**ALBANY COUNTY AIRPORT AUTHORITY
REGULAR MEETING
AGENDA
August 17, 2026**

- 11. Authorization of Change Orders**
 - 11.1 Change Order No. 22: Authorization to Award Contract Change Order #22 to Construction Contract 21-1082-GC for the Pre-TSA Terminal Expansion to MLB Construction Services, LLC**

- 11.2 Change Order No. 15: Authorization to Award Contract Change Order No. 15 to Construction Contract 21-1082-INT STR for the Pre-TSA Terminal Expansion to MLB Construction Services, LLC.**

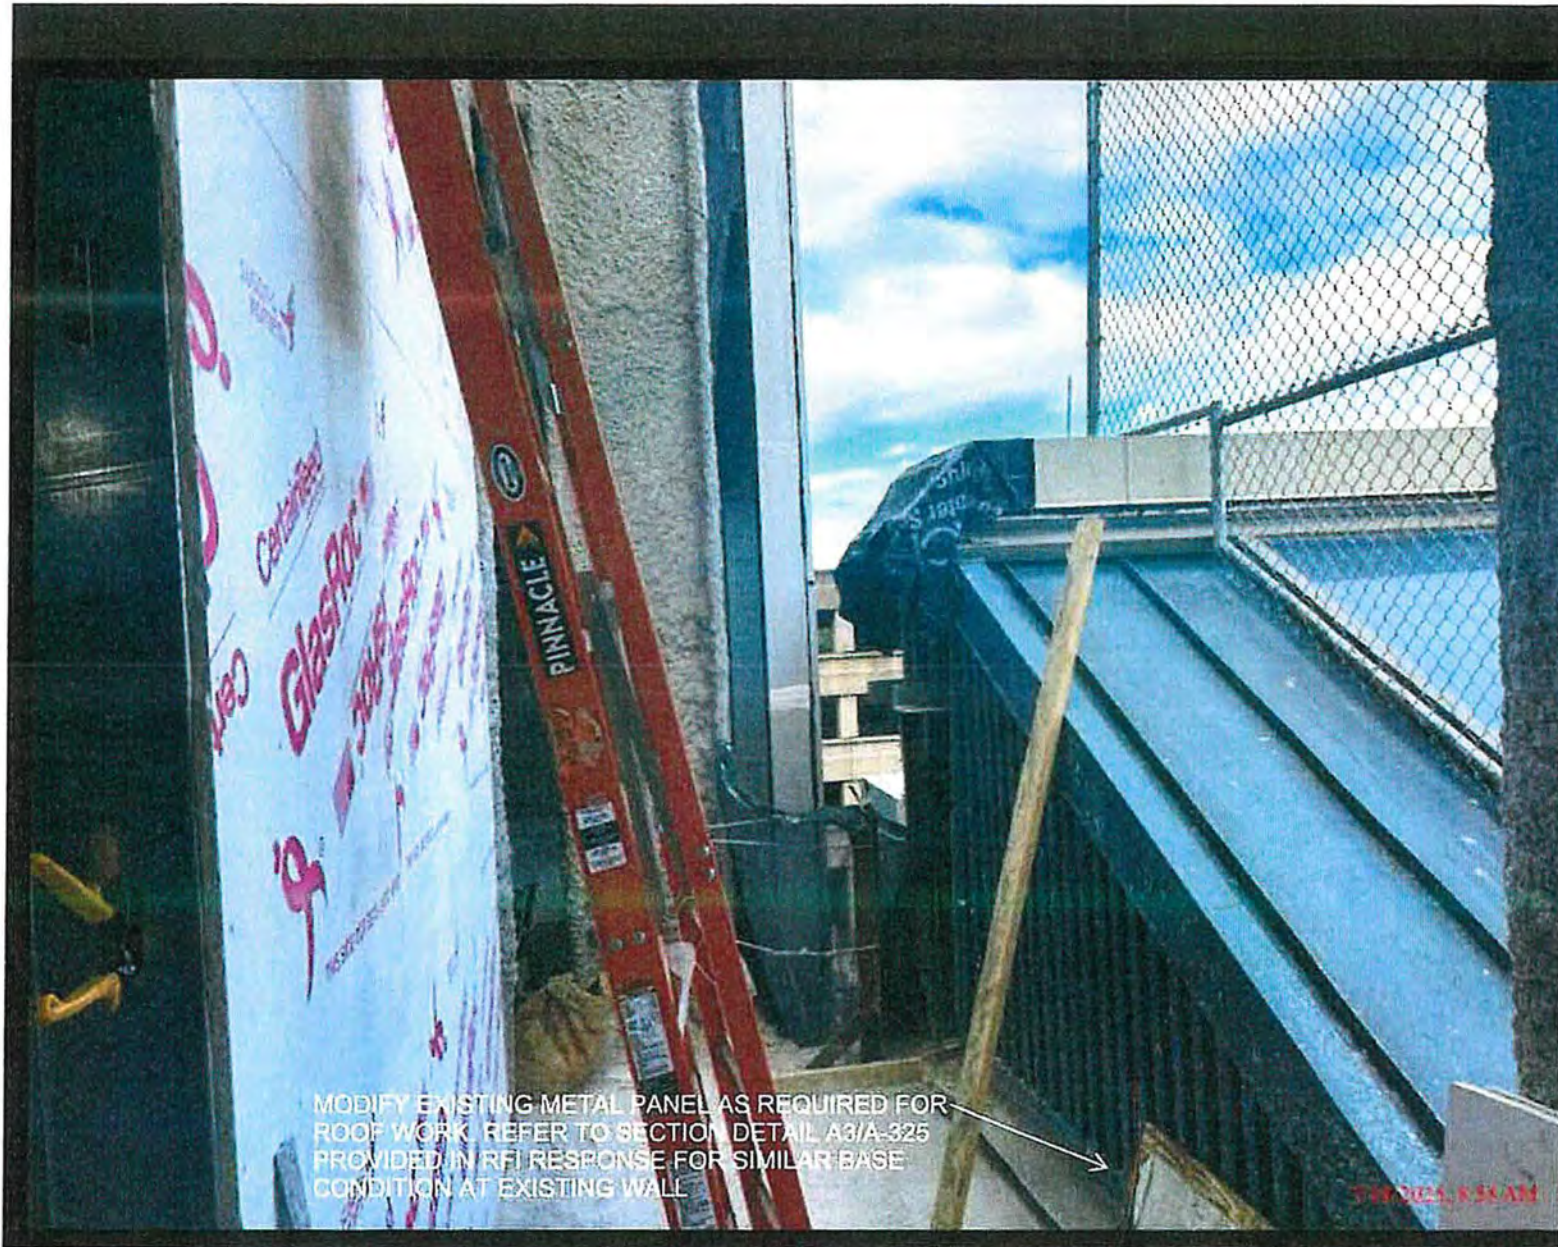
Question Question from Natram Lackraj Turner Construction Company on Wednesday, Jul 9, 2025 at 10:38 AM EDT
Please provide details (shown in blue) for the small roof section shown on the attached sketch on drawing A107.

Refer to TPO Roofing shop drawing submittal detail 5/D1 for similar condition at requested south, east, and north details. Refer to attached section detail A3/A-325 for west detail. Refer to attached photo for west detail at existing clerestory. Section detail will be issued in an ASI.

A-108_ LEVEL 1-4 - ENLARGED PLAN - GARAGE SIDE Rev.18.pdf

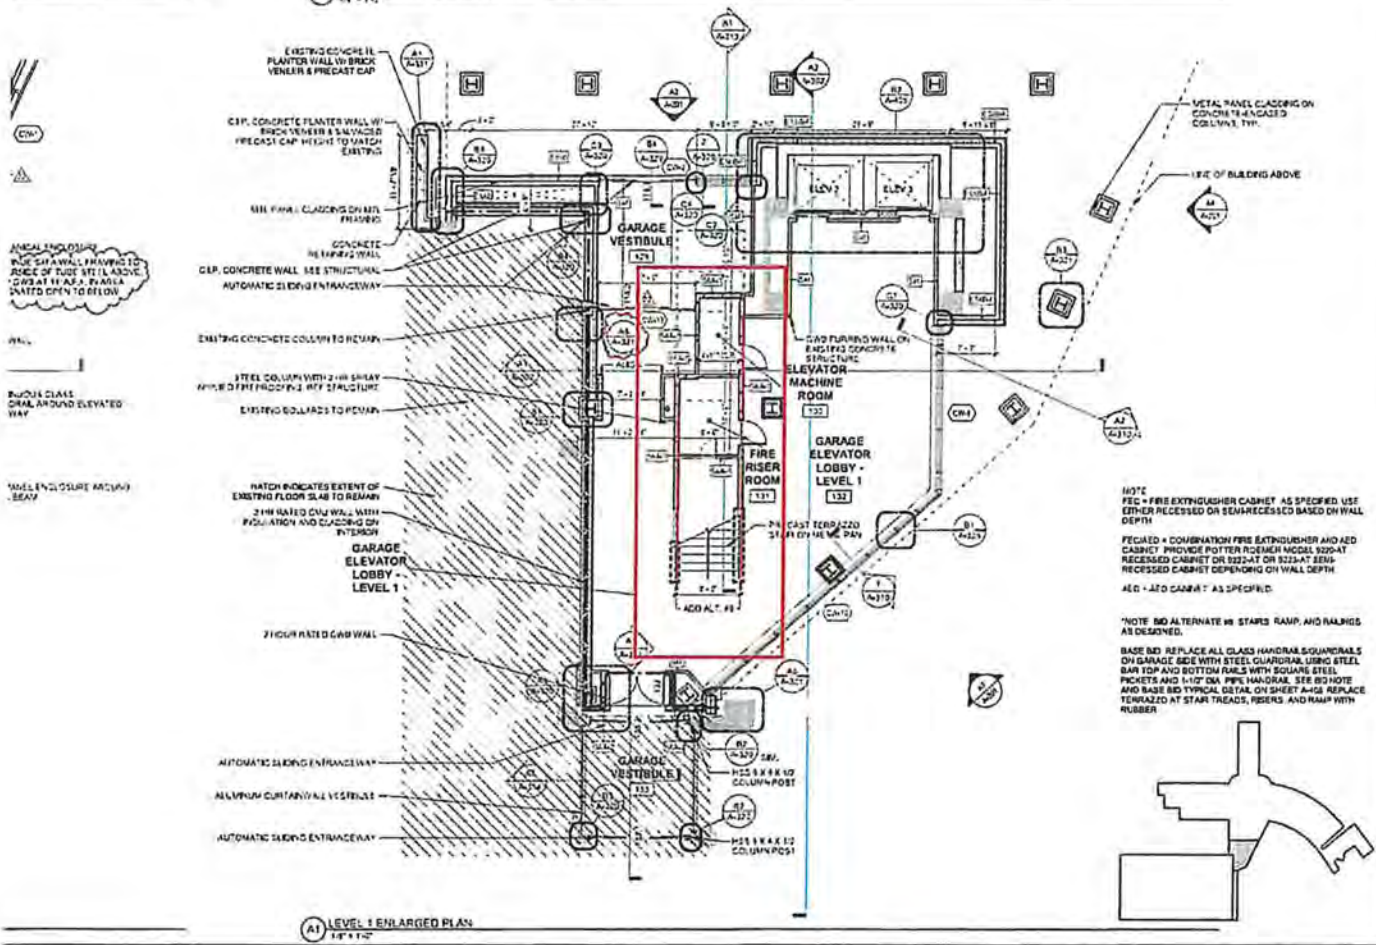
To achieve a 2 hour fire rating of the support post for the garage side stairs
Add a second layer of sheetrock around the stair well and rooms 130,131
The door bucks will need to be changed to 90 minute frames and doors
The buck throat size will need to be change to expect double layer rock
A detail on how to finish the double layer rock that is exposed on the stair stringer is needed
Eclectic boxes will need mud ring extensions

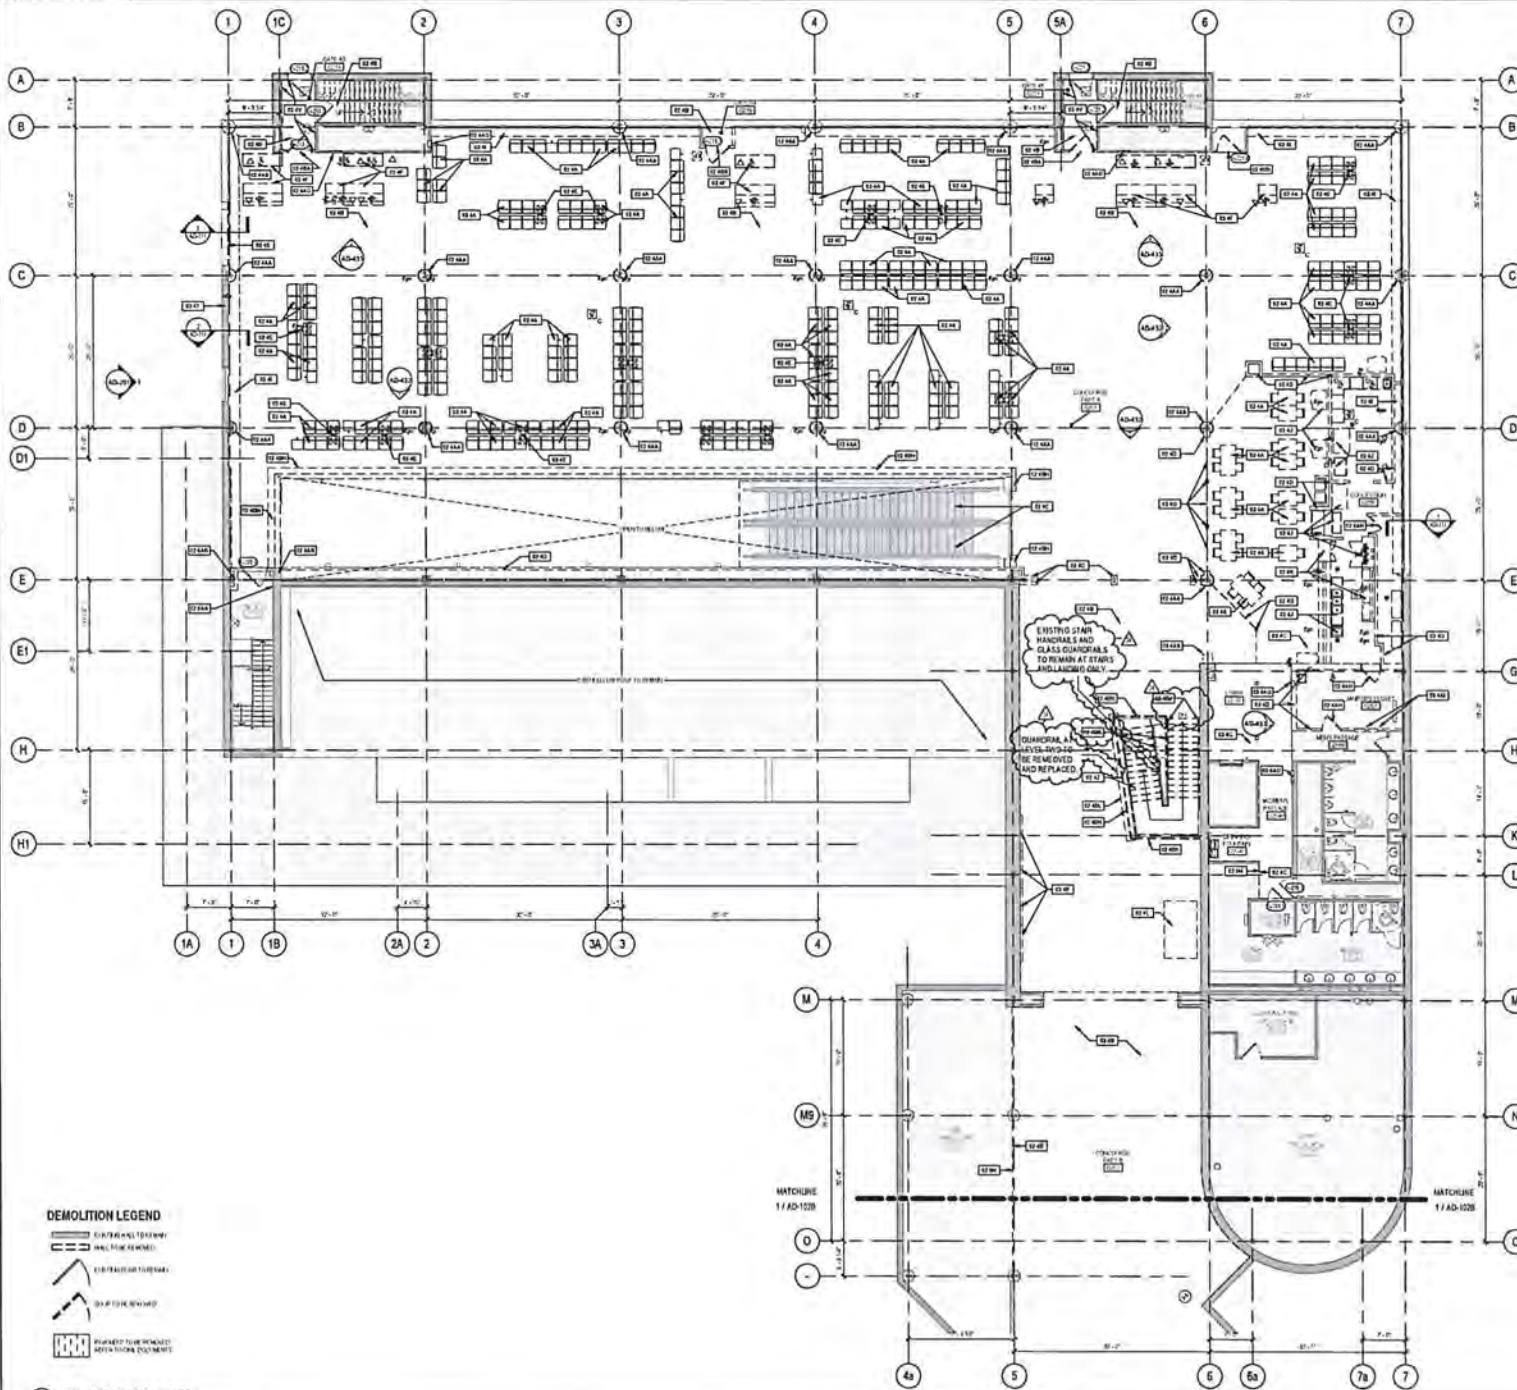
Dwg No.	Title and description
AD-102A	LEVEL 2 -DEMOLITION FLOOR PLAN- PART A Description of the proposed plan and demolition revision at Stair G222.
A-471	ENLARGED STAIR PLANS & SECTIONS Description of the detail changes of the proposed revision at Stair G222.

Drawing Title:
LEVEL 2 - DEMOLITION FLOOR PLAN - PART A DUCT

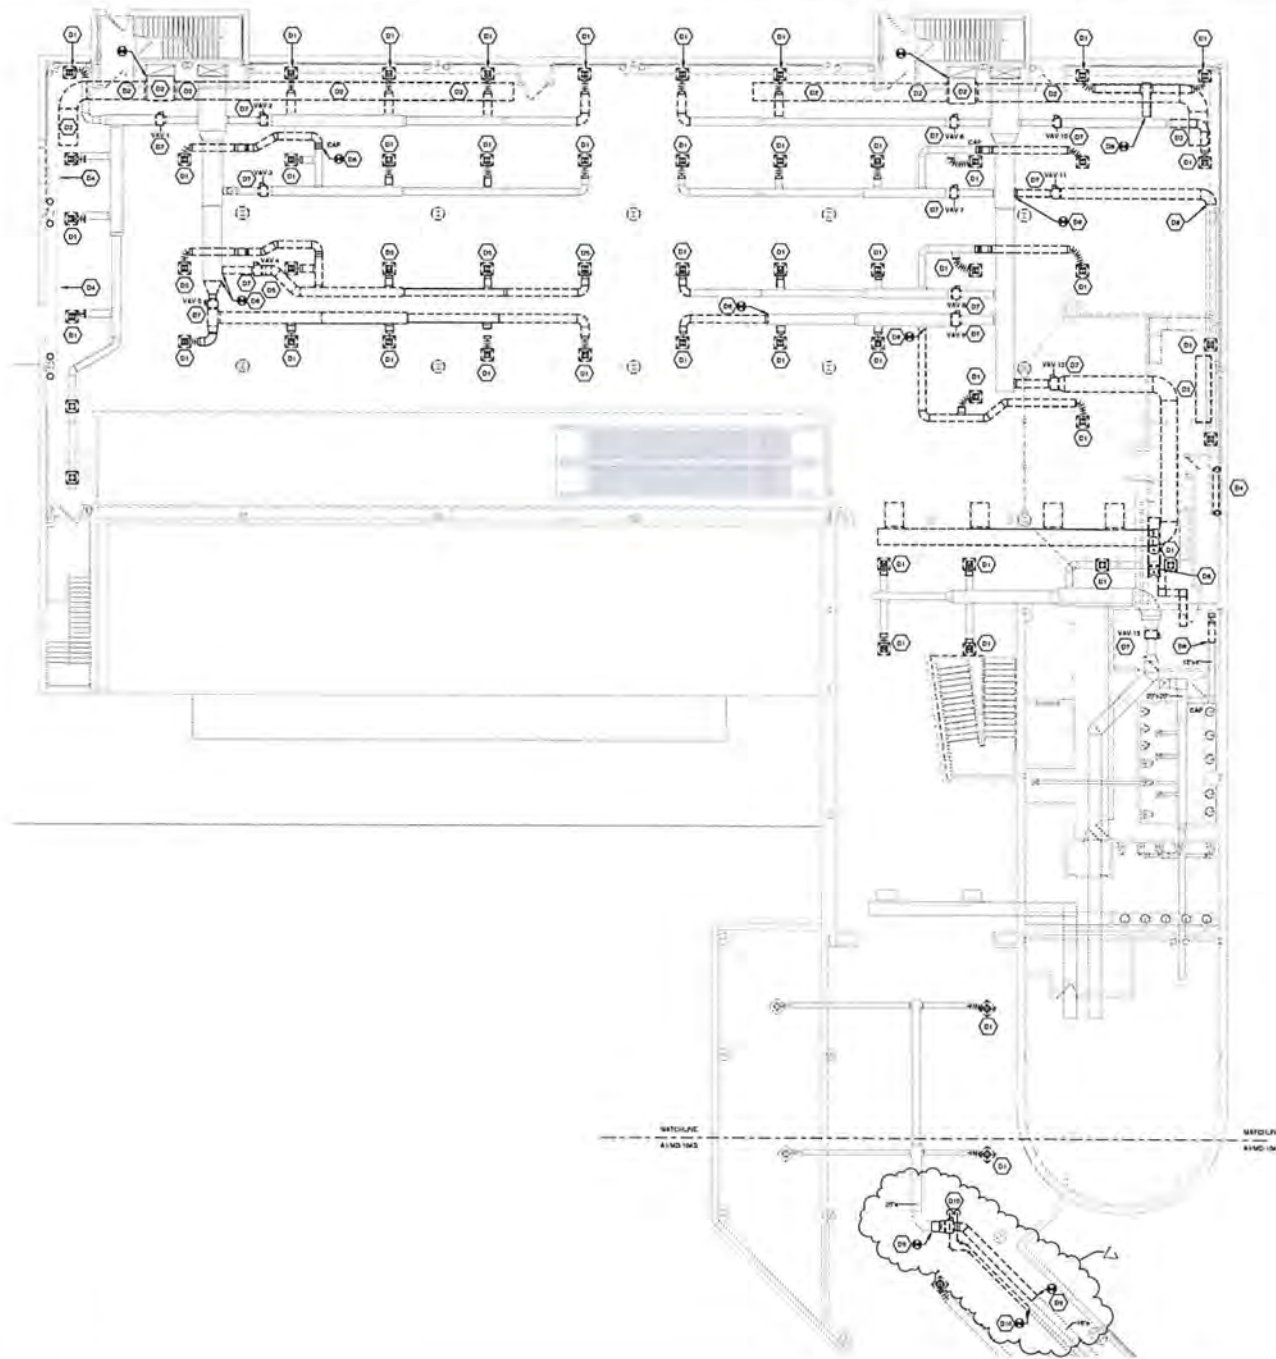
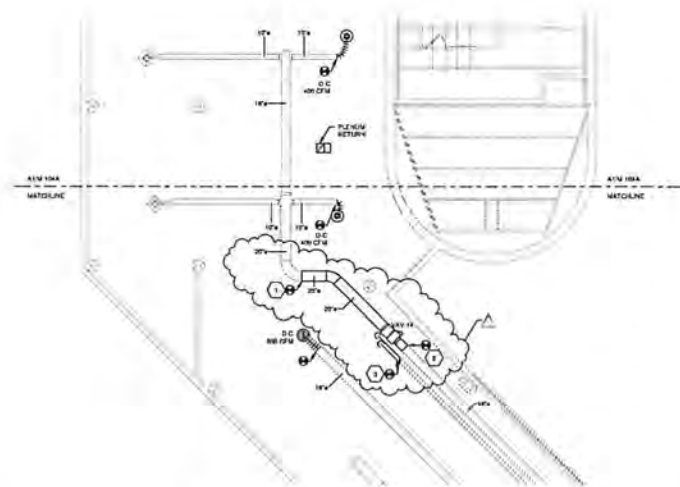
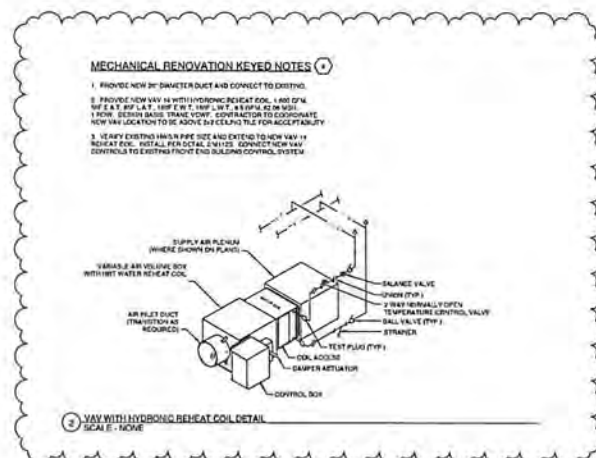
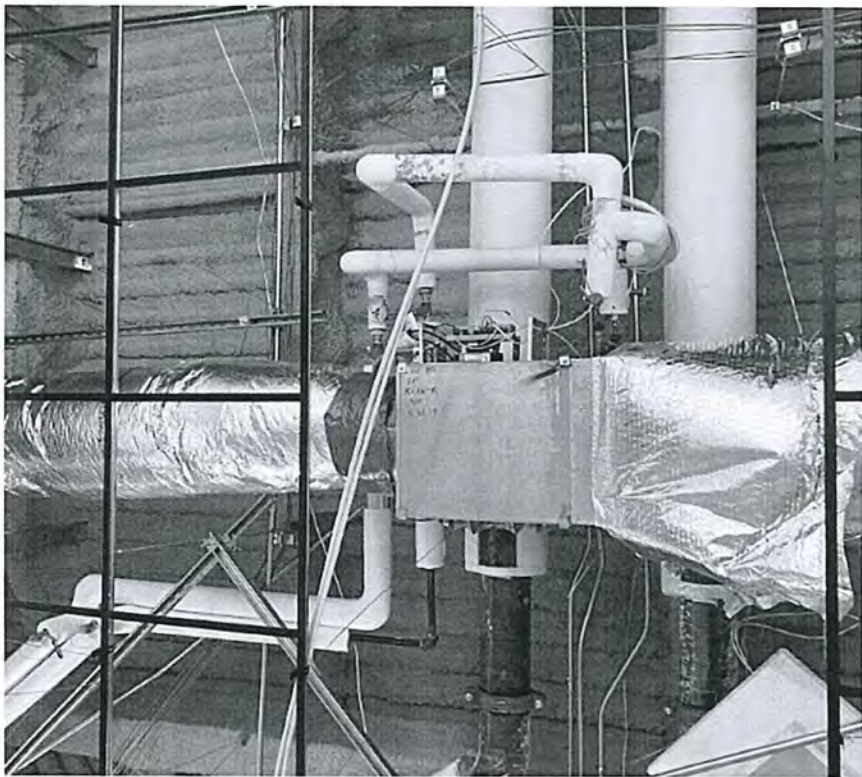
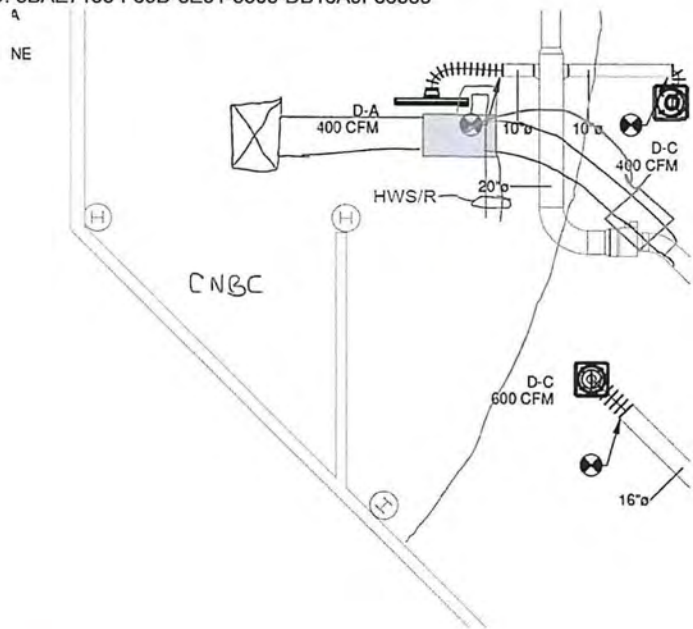
Dwg No.	Title and description
MD-112A	LEVEL 2 – DEMOLITION FLOOR PLAN - PART A DUCT Clouded areas indicate additional notes and areas of duct removal.
MD-112A	LEVEL 2 – FLOOR PLAN – PART B DUCT Clouded areas indicate revision to VAV-14 and specification information.

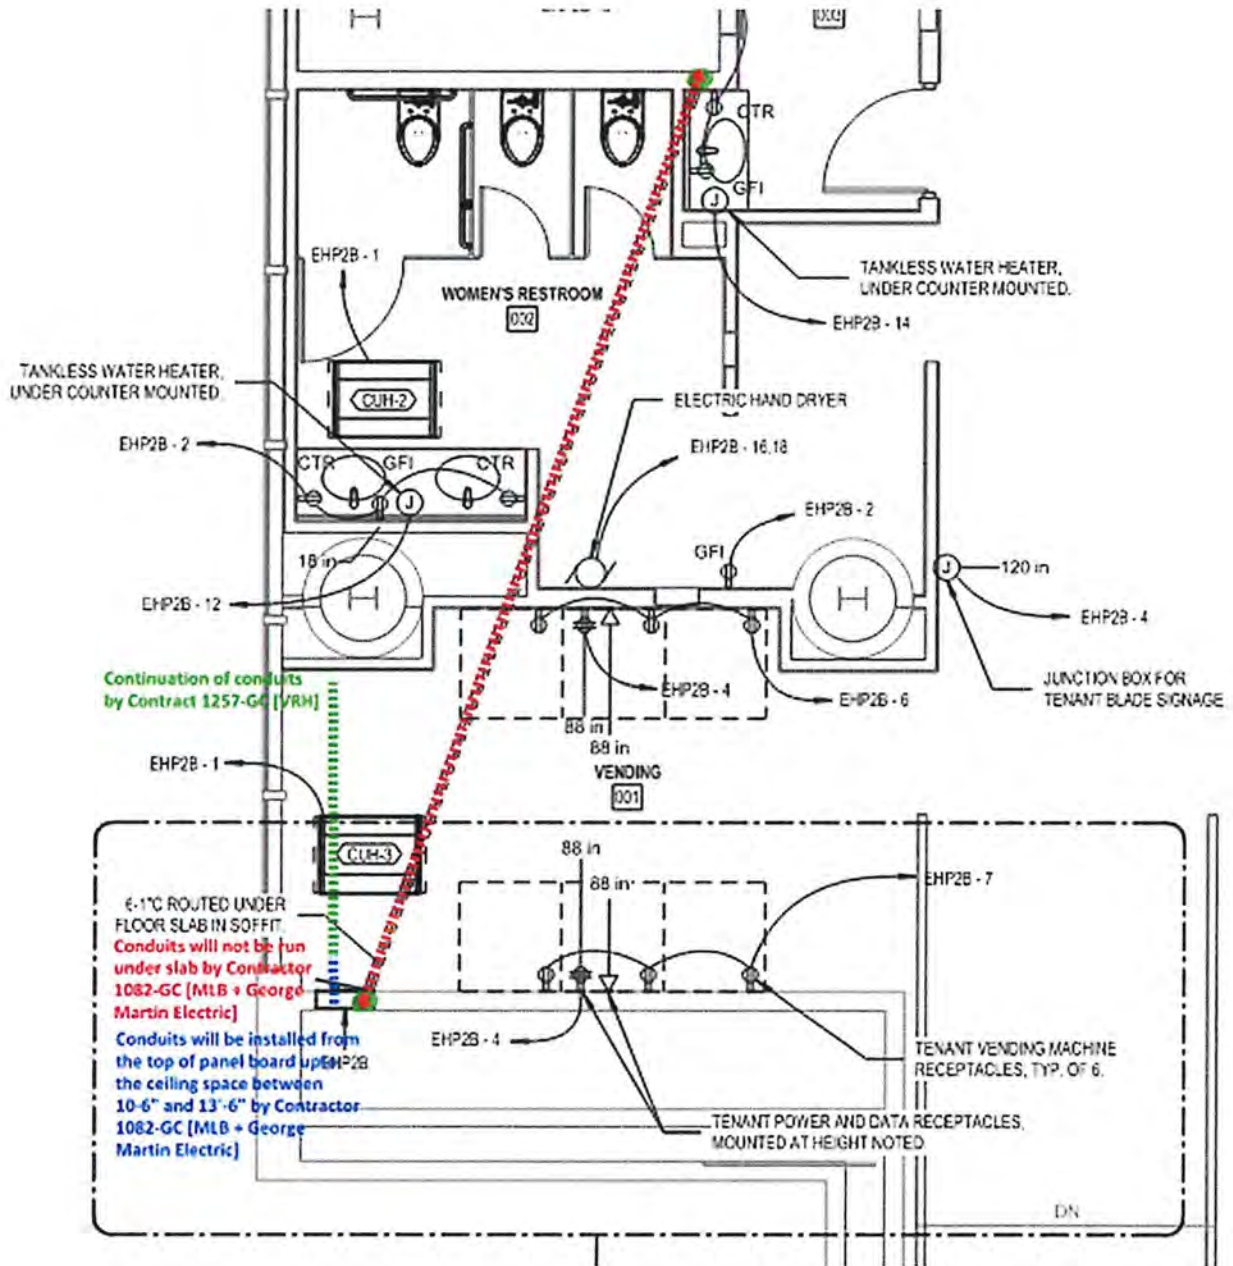
The six 1" conduits indicated to be run under the slab by Contract 1082-INT [MLB + George Martin Electric] will not be installed per Detail A1 on Drawing E-101. Contract 1082-INT will install the conduits from Panel Board EHP2B up to the ceiling space between 10'-6" and 13'-6" above finished floor and stub out from the wall 12". This Contract [1257-GC] shall provide the balance of the conduits as required to provide the circuits as indicated. VRH shall coordinate initial conduit location with George Martin Electric and conduit path with above ceiling contractors for MEP/FP work [see attached]
